Service Information No. 06 / 04

Pressure Switch in the Cooling Circuit

6,7,8,9 M43 900kW/cyl.

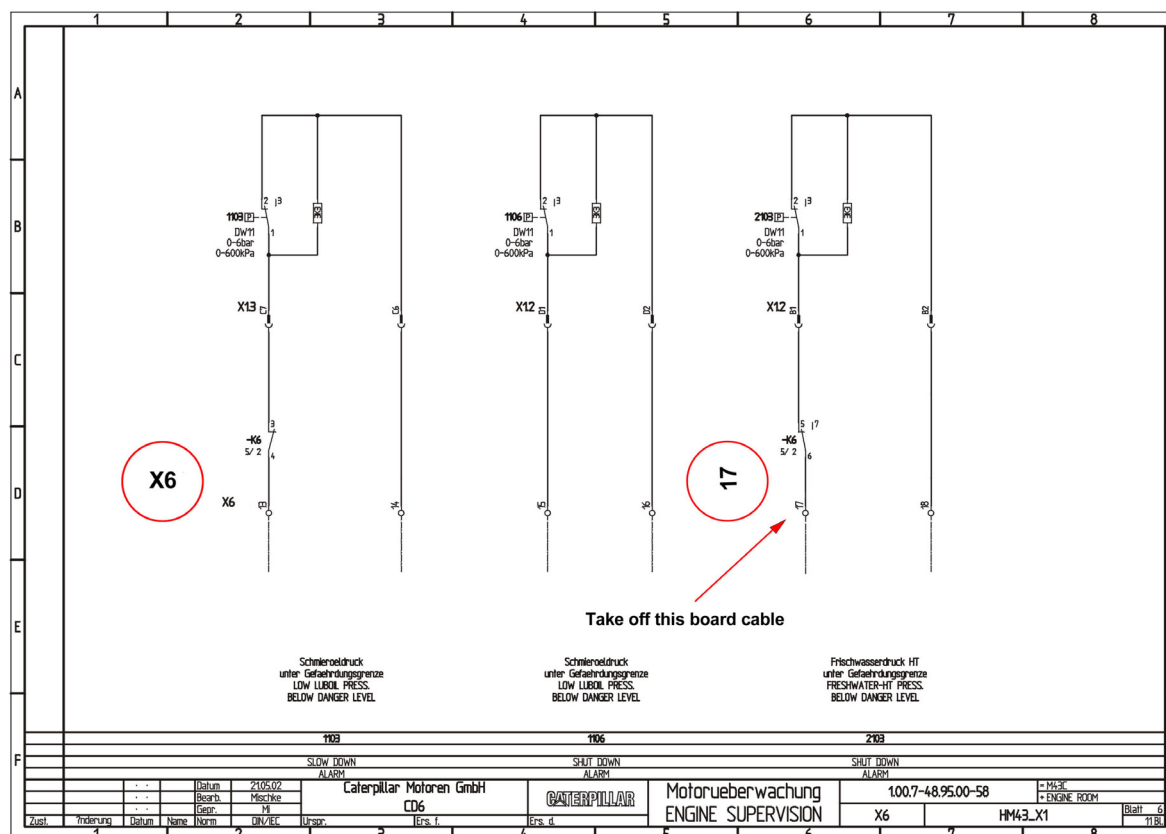
What has to be done:

At terminal strip X6 the board cable must be removed from terminal 17.

Fig. 2

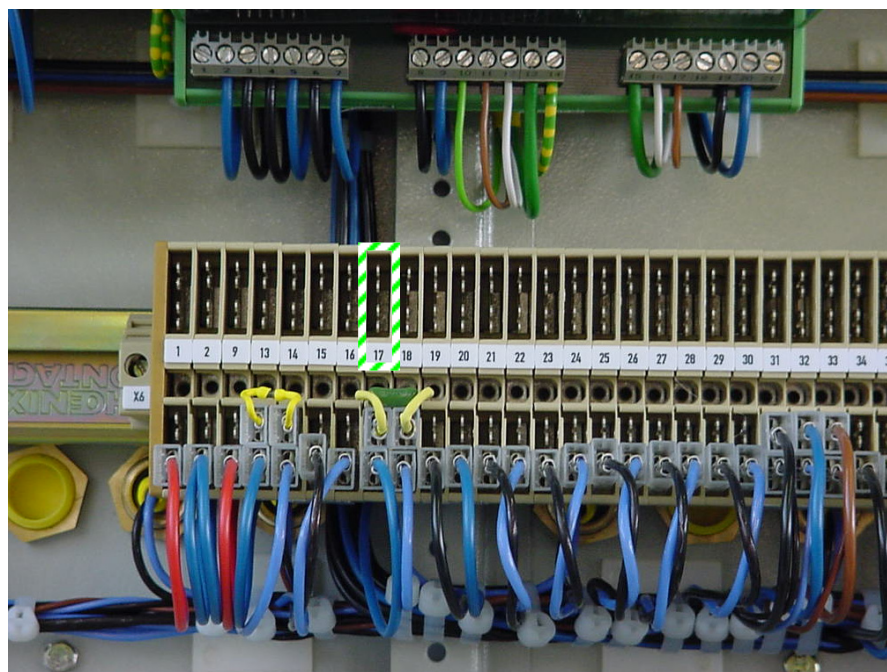
1. Open the switch box on the engine by means of the switch box key.
(located laterally on the engine at the exhaust side)
2. Look for terminal strip X6.
(the code X6 is to be found at left-hand side on the terminal strip, see Fig. 2)
3. Look for terminal 17 of this strip.
(highlighted in Fig.2)
4. Remove the board cable from this terminal 17.
(in Fig. 2 terminal 17 is already shown without board cable)
5. Completely insulate the removed cable end/cable plug with suitable insulating tape.
6. Fasten this free cable end in an appropriate way so that it cannot come into electrical or ground contact.
7. Close the switch box.
